Model: Perfect Binder GB5000	Date: 20-June -08	No.: RD391001a
-------------------------------------	-------------------	----------------

Subject: Firmware Release Note: P-Binder_B1		Prepared by: T.Tadokoro	
From: PPBG QA/Service Planning Dept.			
Classification:	<input type="checkbox"/> Troubleshooting	<input type="checkbox"/> Part information	<input type="checkbox"/> Action required
	<input type="checkbox"/> Mechanical	<input type="checkbox"/> Electrical	<input type="checkbox"/> Service manual revision
	<input type="checkbox"/> Paper path	<input type="checkbox"/> Transmit/receive	<input type="checkbox"/> Retrofit information
	<input checked="" type="checkbox"/> Other ()

Subject: STAY: Parts catalog correction		Prepared by: T. Tadokoro	
From: PPBG QA/Service Planning Dept.			
Classification:	<input type="checkbox"/> Troubleshooting <input type="checkbox"/> Mechanical <input type="checkbox"/> Paper path <input type="checkbox"/> Other ()	<input checked="" type="checkbox"/> Part information <input type="checkbox"/> Electrical <input type="checkbox"/> Transmit/receive	<input type="checkbox"/> Action required <input type="checkbox"/> Service manual revision <input type="checkbox"/> Re

6.Transit Pass Unit 3 (D391)

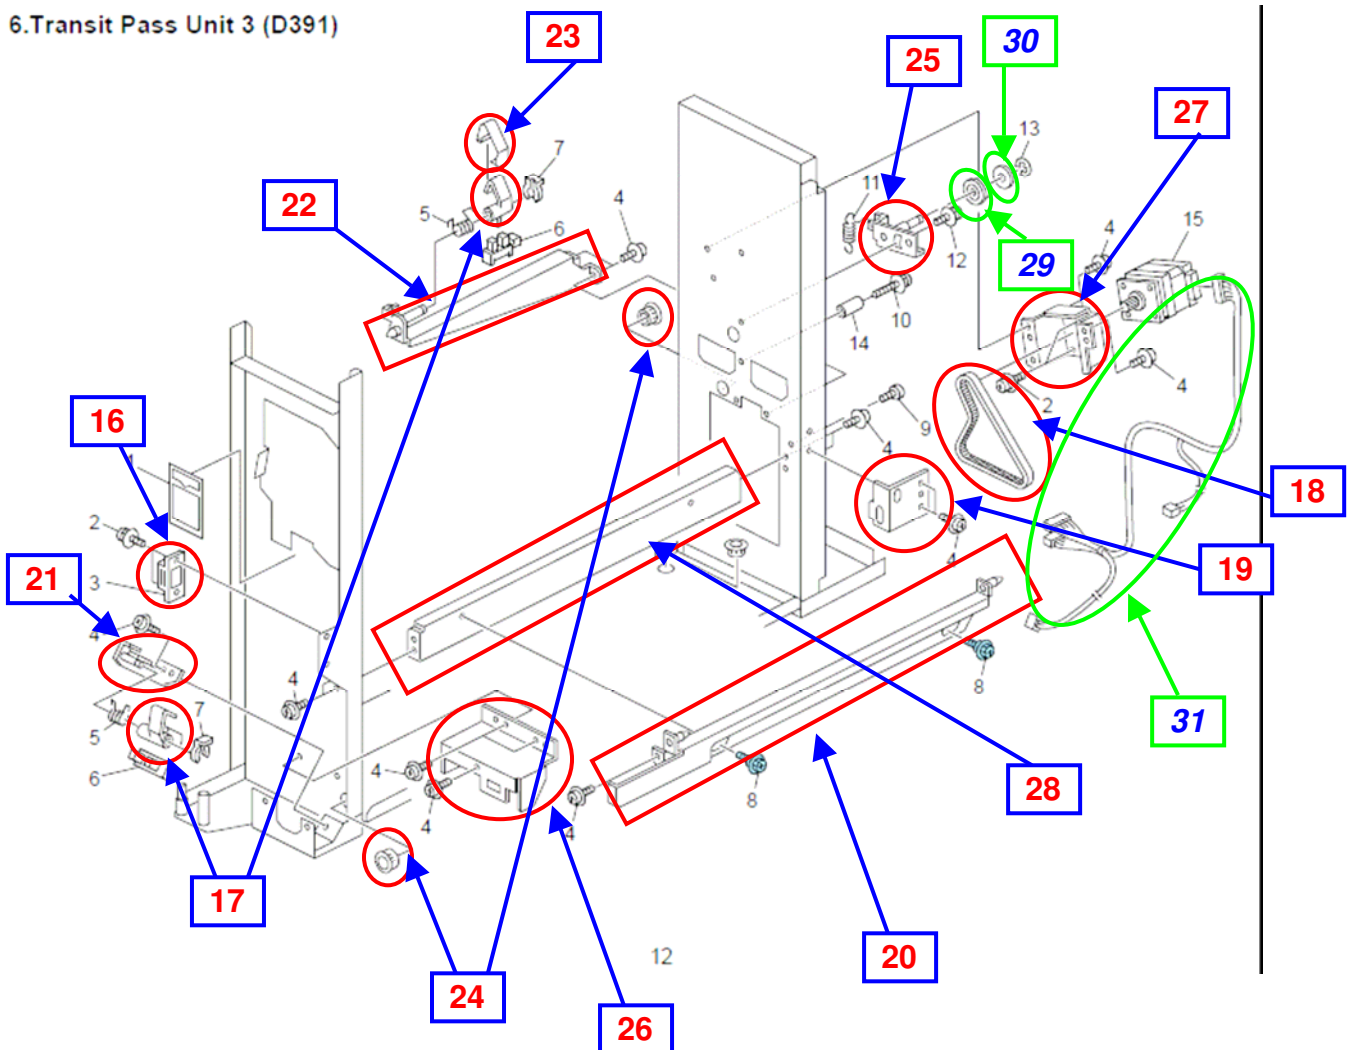
New Part Number	Description	Q'ty	Int	Page	Index	Note
B6601111	Magnet Catch:13N:PF2214P393A	1	-	12	16	Add
D3911328	Lever:Sensor:PF4140P614B2	2	-	12	17	Add
D3914525	Synchronous Belt:NS-BLT00452A	1	-	12	18	Add
B6601436	Bracket:Ground Plate:PF4147P139A	1	-	12	19	Add
B6601212	Lever:Coupling:PF4147P197A	1	-	12	20	Add
D3914537	Bracket:Sensor:PF4140K059:PEEN	1	-	12	21	Add
D3914538	Bracket:Sensor:Release:PF4165K608	1	-	12	22	Add
D3914539	Spring Plate: Sensor: Release: PF4140P714	1	-	12	23	Add
D3914540	Timing Pulley:E450001234	2	-	12	24	Add
D3914541	Bracket:Tightener:PF4165K606	1	-	12	25	Add
D3914542	Cover:Sensor:Release:PF4165Q619	1	-	12	26	Add
D3914545	Bracket:Dc Stepper Motor: PF4140P629	1	-	12	27	Add
D3914547	Stay:Right:PF4165Q603	1	-	12	28	Add
D3914543	ROLLER:SYNCHRONOUS BELT: PR5100P216	1	-	12	29	Add
D3914544	FLANGE:ROLLER:PF4099P950	1	-	12	30	Add
D3914546	HARNESS:JOINT UNIT:PF4165K906	1	-	12	31	Add

7.Inserter Section 1 (D391)

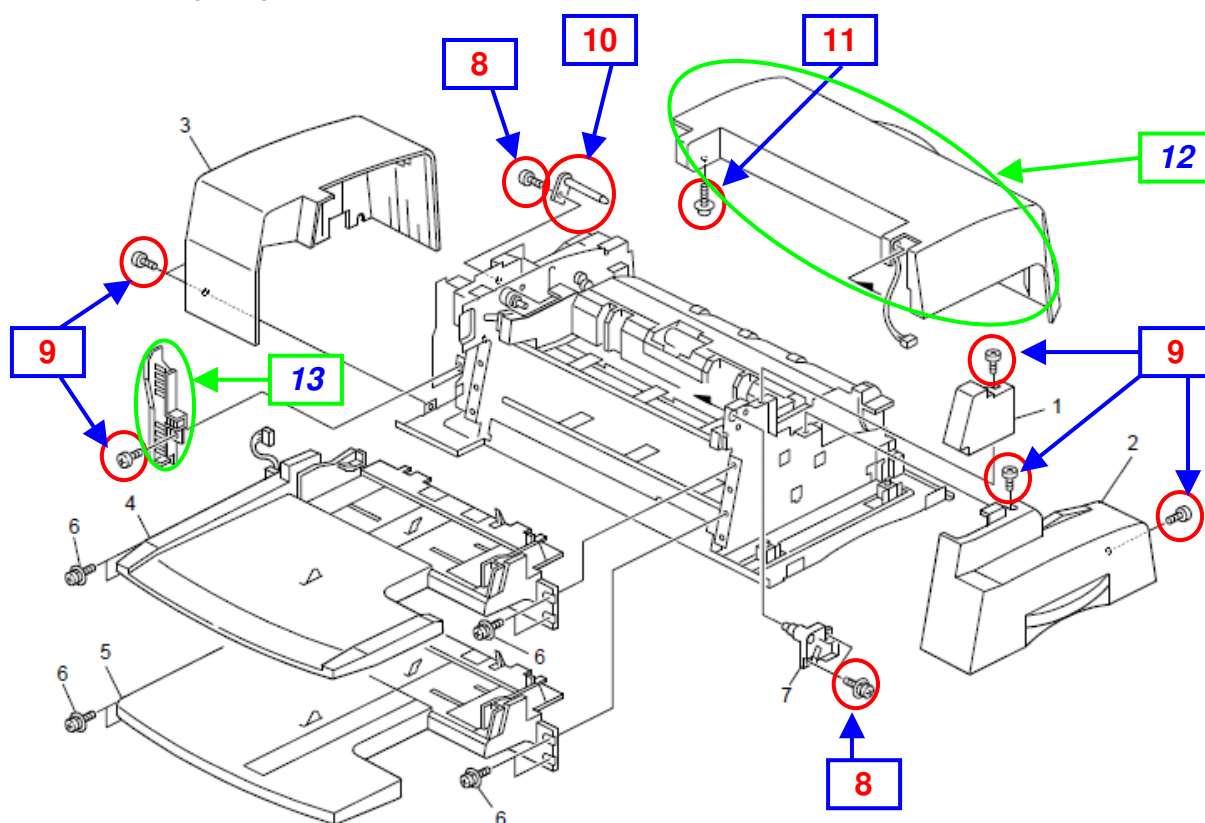
Part Number	Incorrect Description	Correct Description	Q'ty	Int	Page	Index
D3914030	Cover: Front: Sub: PF3091P002A	Cover: Front: Sub: PF3099P002	1	-	14	1
D3914029	Cover: Front: PF3091P001A	Cover: Front: PF3099P001	1	-	14	2
D3914031	Cover: Rear: PF3091P003A	Cover: Rear: PF3099P003	1	-	14	3
D3914026	Tray Unit: Upper: PF3091K152A: Ass'y	Tray Unit: Upper: PF3099K152: Ass'y	1	-	14	4
D3914025	Tray Unit: Lower: PF3091K144A: Ass'y	Tray Unit: Lower: PF3099K144: Ass'y	1	-	14	5

8.Inserter Section 2 (D391)

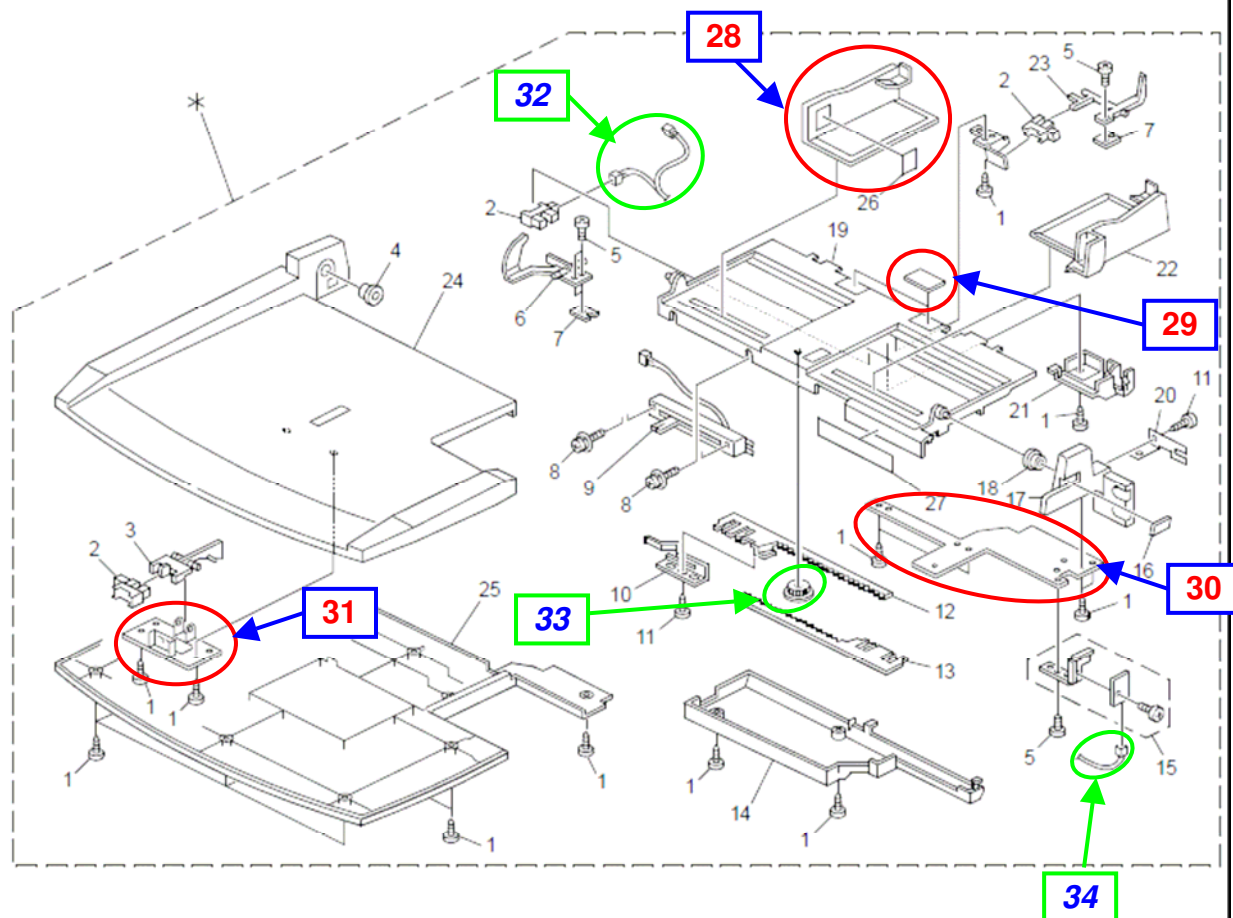
Part Number	Incorrect Description	Correct Description	Q'ty	Int	Page	Index
D3914026	Tray Unit: Upper: PF3091K152A:Ass'y	Tray Unit: Upper: PF3099K152:Ass'y	1	-	16	*
D3914061	Lever:PF3091P046A	Lever:PF3099P046	1	-	16	3
D3914063	Lever:PF3091P048A	Lever:PF3099P048	1	-	16	6
D3914046	Cover:Tray:Upper Lower: PF3091P021A	Cover:Tray:Upper Lower: PF3099P021	1	-	16	14
D3914044	Tray:Base:Sub:PF3091P015A	Tray:Base:Sub:PF3099P015	1	-	16	17
D3914021	Tray:Upper Lower:Bin: Upper: PF3091K102A	Tray:Upper Lower:Bin:Upper: PF3099K102	1	-	16	19
D3914047	Guide:Tray:Upper:Front: PF3091P022A	Guide:Tray:Upper:Front: PF3099P022	1	-	16	22

9.Inserter Section 3 (D391)

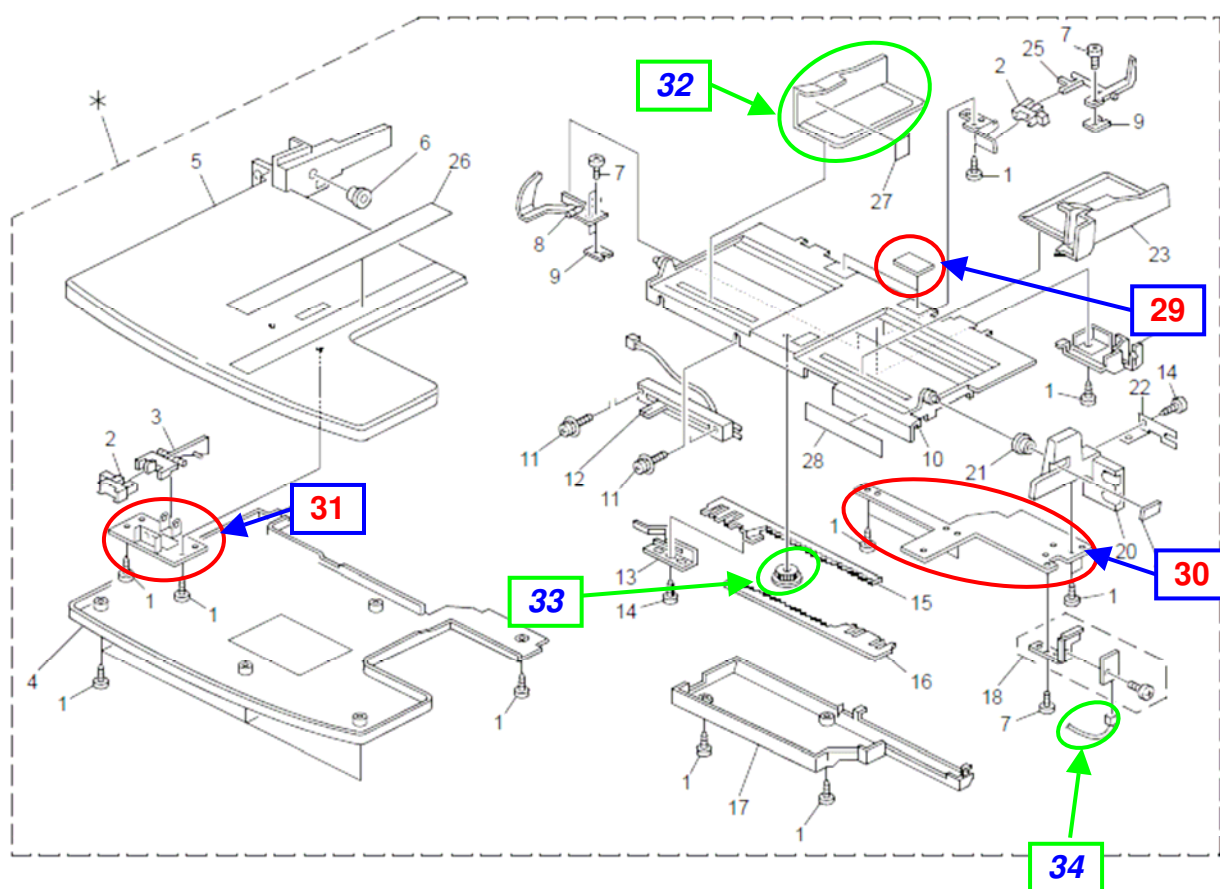
Part Number	Incorrect Description	Correct Description	Q'ty	Int	Page	Index
D3914025	Tray Unit: Lower: PF3091K144A:Ass'y	Tray Unit: Lower: PF3099K144:Ass'y	1	-	18	*
D3914045	Cover:Tray:Lower: PF3091P017A	Cover:Tray:Lower: PF3099P017	1	-	18	4
D3914033	Base:Tray:Lower:PF3091P014A	Base:Tray:Lower: PF3099P014	1	-	18	5
D3914063	Lever:PF3091P048A	Lever:PF3099P048	1	-	18	8
D3914044	Tray:Base:Sub:PF3091P015A	Tray:Base:Sub:PF3099P015	1	-	18	20
D3914048	Guide:Tray:Lower:Front: PF3091P024A	Guide:Tray:Lower:Front: PF3099P024	1	-	18	23
D3914022	TRAY:UPPER LOWER: BIN: LOWER: PF3091K103A	TRAY:UPPER LOWER: BIN: LOWER: PF3099K103A	1	-	18	10

10.Inserter Section 4 (D391)

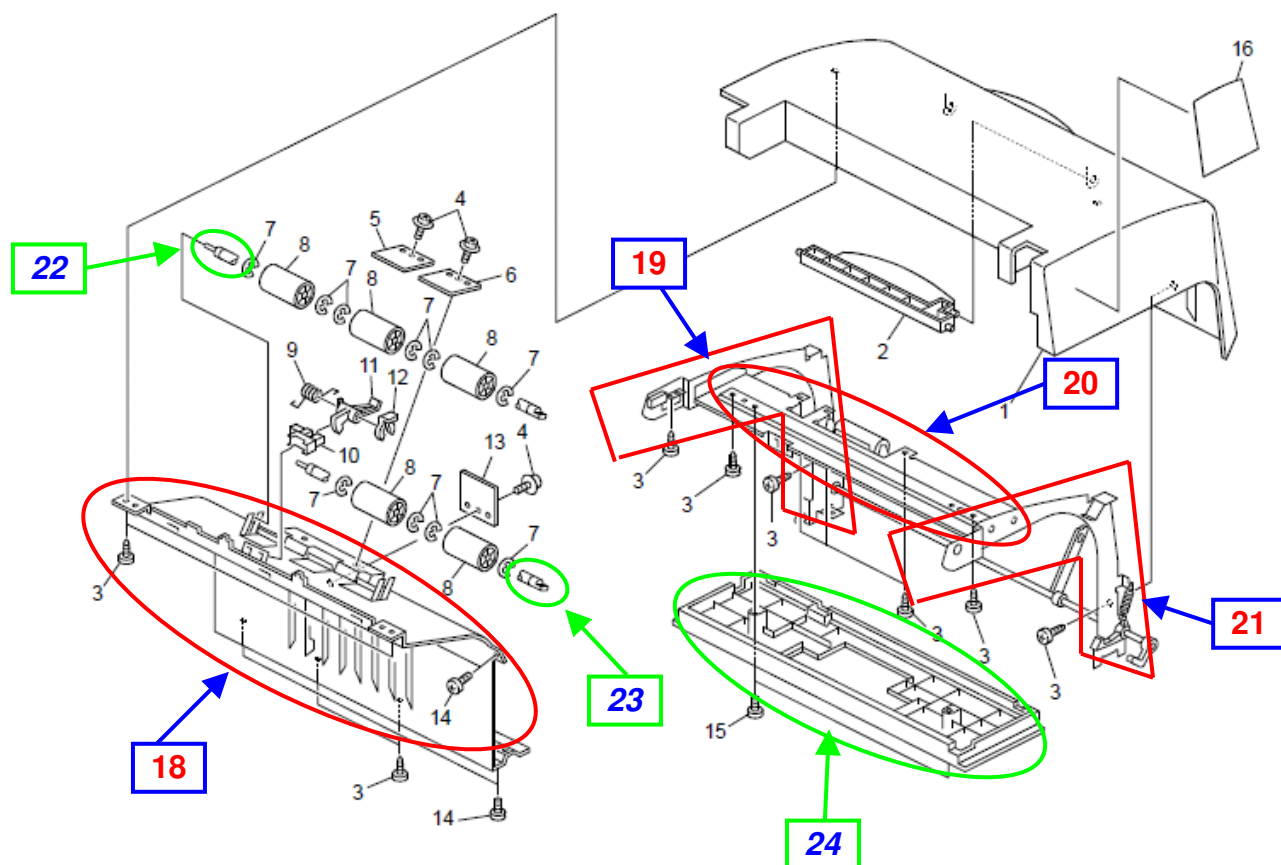
Part Number	Incorrect Description	Correct Description	Q'ty	Int	Page	Index
D3914032	Cover:Upper:PF3091P004A	Cover:Upper:PF3099P004	1	-	20	1
D3914052	Lever:Open And Close:Cover:Upper: PF3091P029A	Lever:Open And Close:Cover:Upper: PF3099P029	1	-	20	2

56.Cover Feed Regist Section 2 (D391)

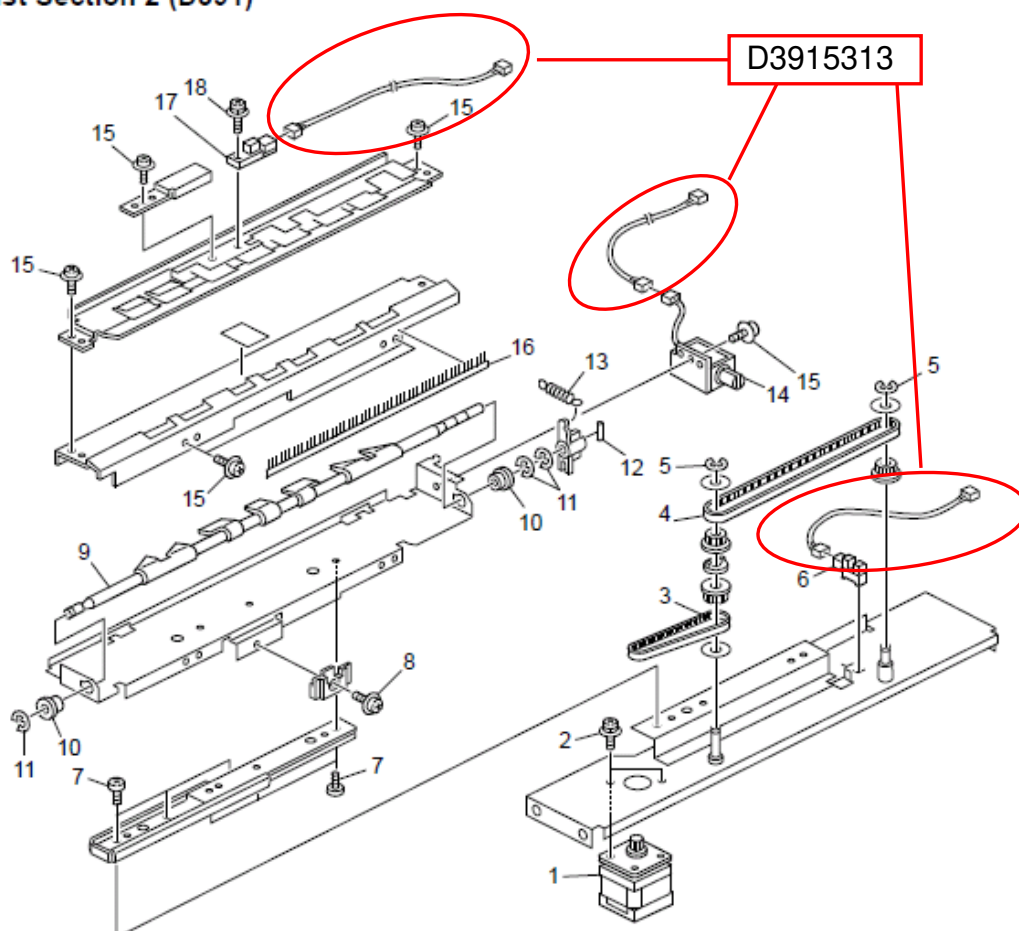
New Part Number	Description	Q'ty	Int	Page	Index	Note
D3915313	HARNESS:REGISTRATION:PF4140K681:ASS'Y	1	-	112	19	Add

89.Book Stacking Section 3 (D391)

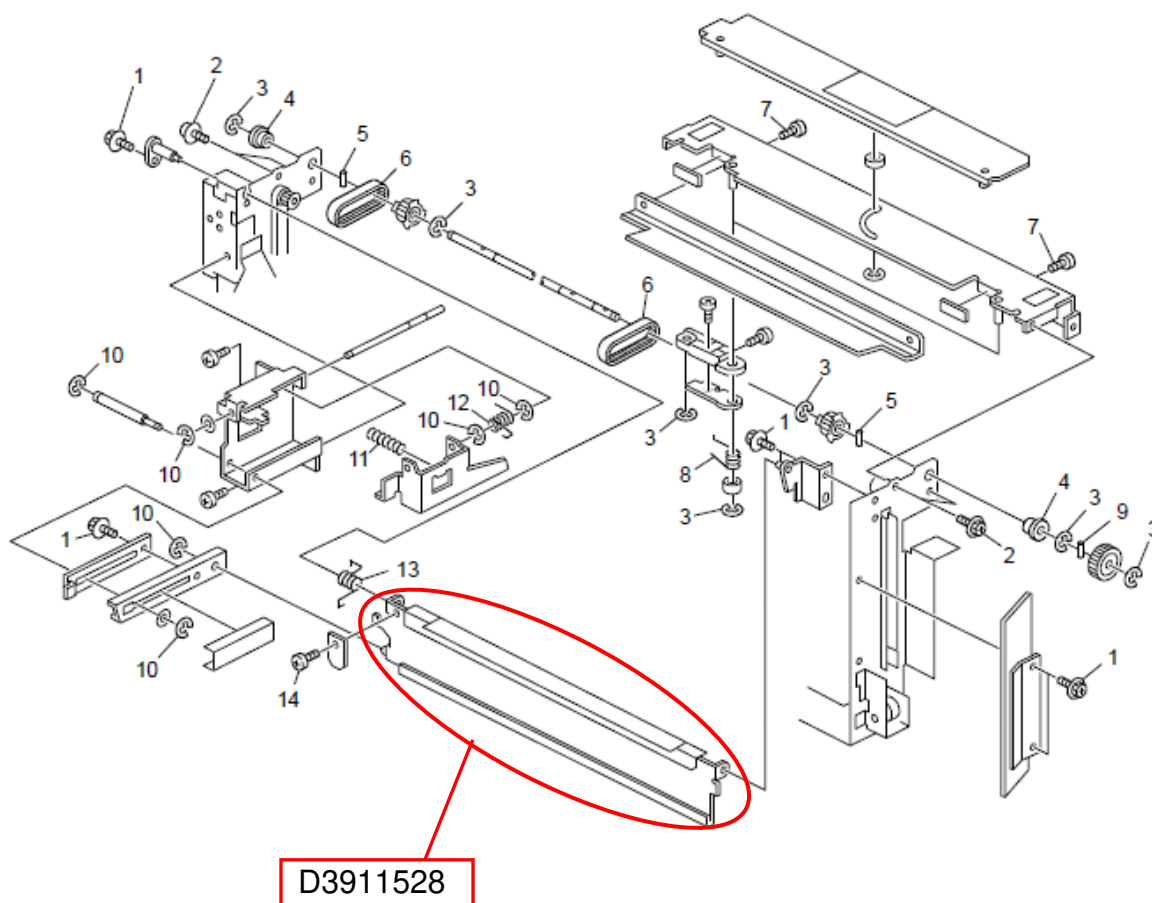
New Part Number	Description	Q'ty	Int	Page	Index	Note
D3911528	SEPARATION PLATE: EXHAUST: PF4164L852	1	-	178	15	Add

84.Waste Paper Case Section 2 (D391)

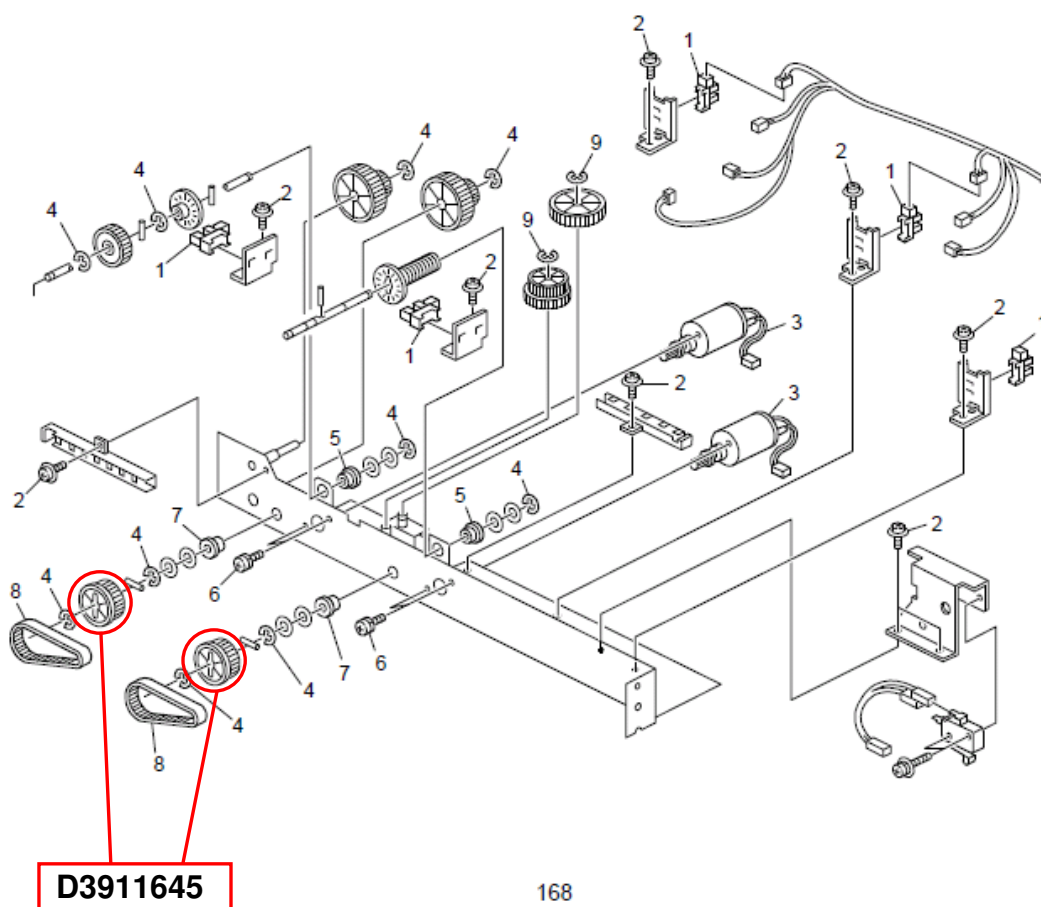
New Part Number	Description	Q'ty	Int	Page	Index	Note
D3911645	TIMING PULLEY:T40:PF4140Q402	2	-		10	Add

63.Cover Feed Path Section 7 (D391)

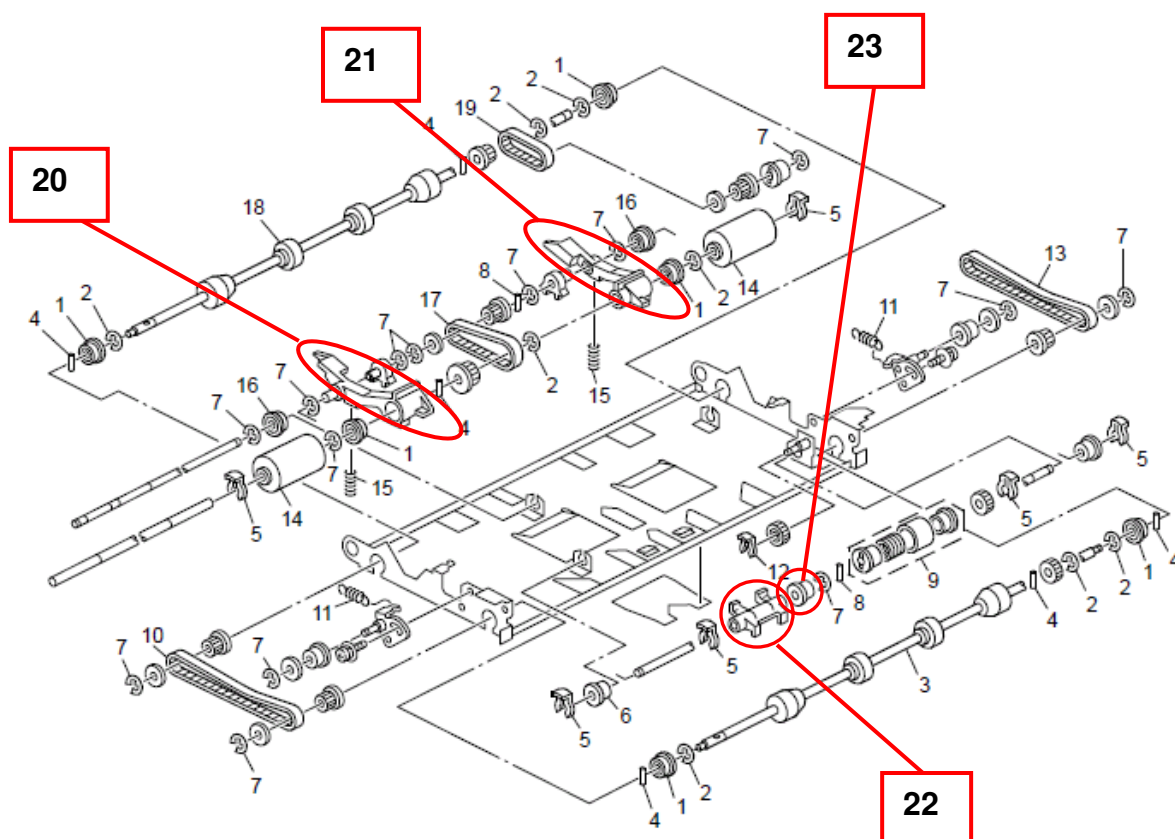
New Part Number	Description	Q'ty	Int	Page	Index	Note
D3911649	ARM:ROLLER:INNER BACK:PF4140P690	1	-	127	20	Add
D3911650	ARM:ROLLER:FRONT:PF4140P691	1	-	127	21	Add
D3911652	ARM:OPEN AND CLOSE:PF4140P693	1	-	127	22	Add
D3911653	ROLLER BEARING:PF4051P347	1	-	127	23	Add
